# UNITED STATES PATENT AND TRADEMARK OFFICE

10/585,454

## **DETAILED ACTION**

Claims 1-8 and 10-11 are rejected under 35 U.S.C. 103(a) as being unpatentable over Taubmann et al. (EP 1068093 B1).

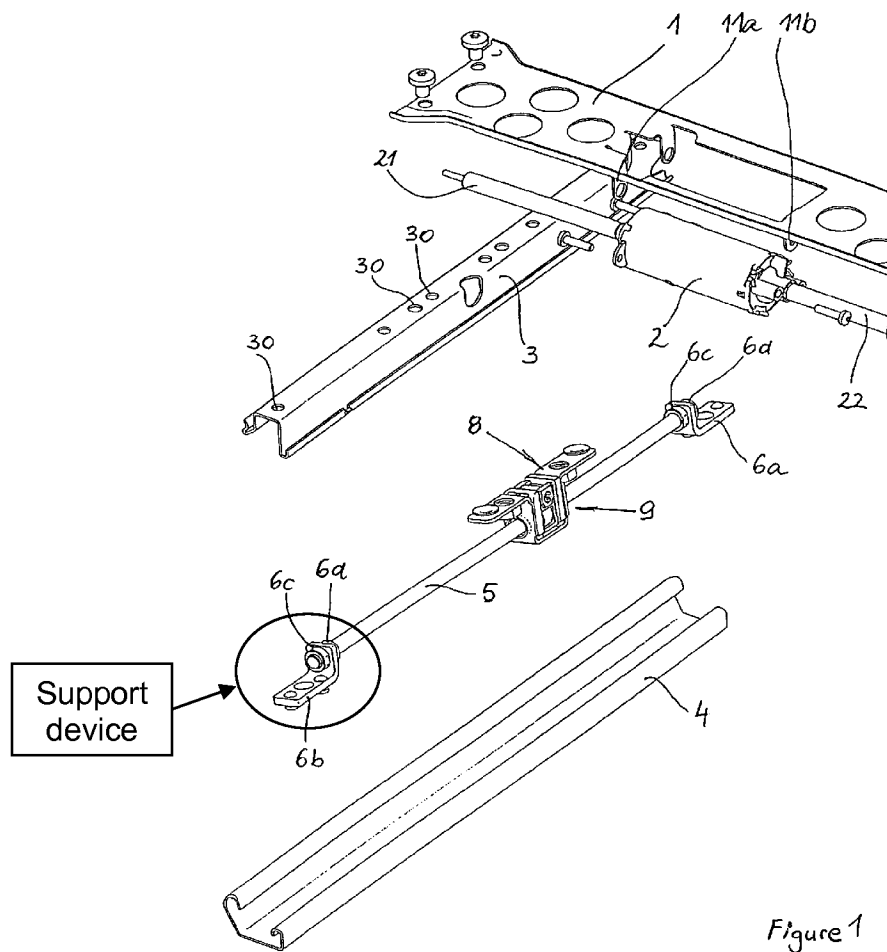
Regarding claim 1, Taubmann discloses a drive having a spindle **5** which is attached to a first rail **4** of two rails **3, 4** that are adjustable relative to one another by means of at least one support (as shown in Fig. 1 below) that is located on the end of the spindle **5**, and with a gear mechanism **9** which is driven by a motor **2** and which is

With regards to claim 2, Taubmann teaches the drive, characterized in that two such supports (see Fig. 1 below) are provided, of which in each case one support device serves to support one of two ends of the spindle **5**.

Figure 2

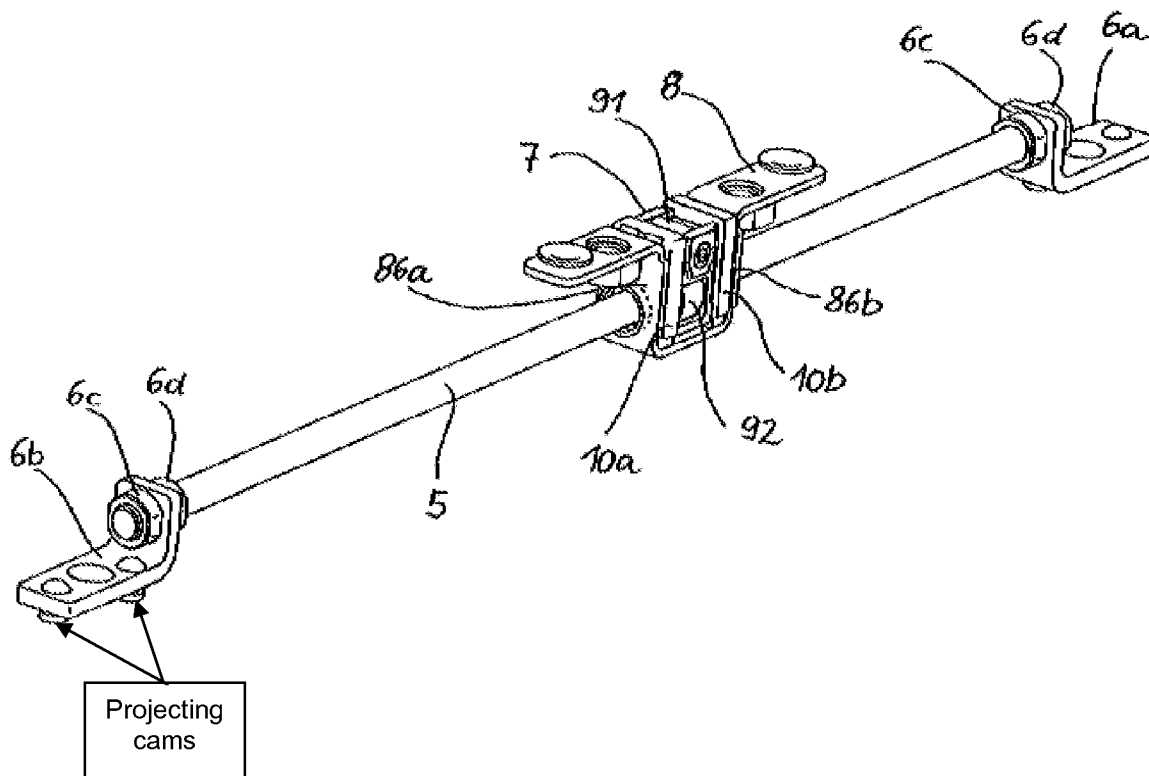
The Examiner further notes that the trough-shaped, outer bearing surface of the present invention, is merely a gusset, for providing additional support. It is well known in the art to provide gussets, to add stability to elements as seen in: US 5267717 to Isomura, element **124**; US 5516071 to Miyauchi, element **13**, and US 5259257 to Mouri, element **13**. The claim would have been obvious because the substitution of one known element for another would have yielded predictable results to one of ordinary skill in the art at the time of the invention.

Figure 15

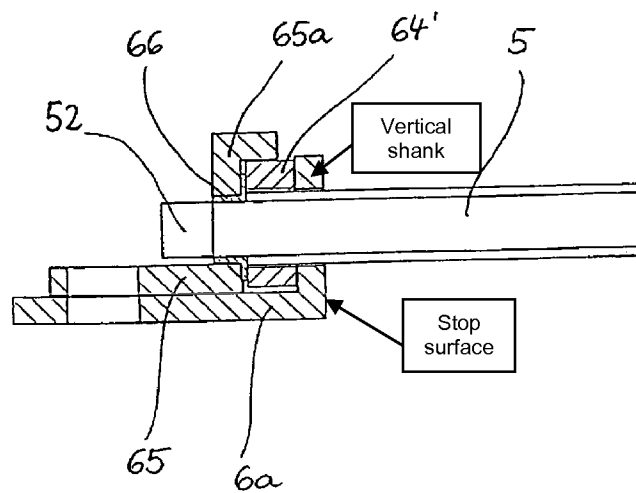
Regarding claim 11, Taubmann goes on to disclose the drive, characterized in that the horizontal limb **6b** having attachment hole (as shown in Fig. 14) so that it can be attached to the vehicle floor.
